Service Bulletin

ubject: GH OIL CONSUMPTION DUE TO WRONG AIR INTAKE HOSE SERVICE PARTS	Bulletin No:	01-030/09
	Last Issued:	07/10/2009

2004-2008 RX-8

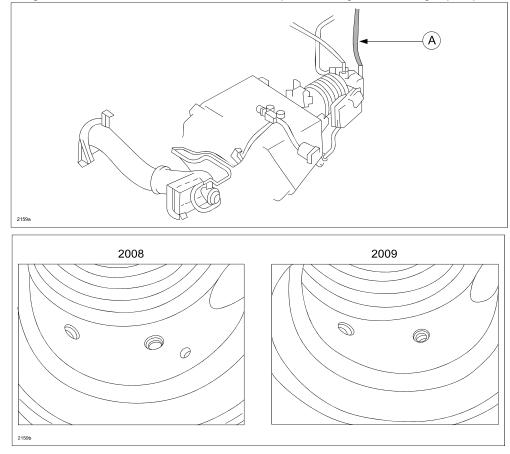
Some vehicles may experience high oil consumption if the air intake hose was replaced with service parts. The cause of this is the number of ventilation holes on the hose was changed from three (3) to two (2) for 2009. However, it appears that the service part hose for 2009 was shipped for 2004-2008 RX-8 by mistake since January 8, 2008. If the hose for a 2009 model is installed on a 2004-2008 RX-8, the barometric pressure, which is normally applied on a small hose (A) connected to the metering oil nozzle is plugged. Engine vacuum then goes to the metering oil nozzle instead so that oil is supplied inside the engine is more than the Metering Oil Pump (MOP) injects, resulting in high oil consumption.

Verify if the vehicle has had the air intake hose replaced after January 8, 2008, then replace the hose with the correct one.

Part Number	Description	Qty.	Notes
N3H1-13-221E	Hose, Air	1	For 2004-2008 RX-8 (with 3 holes)
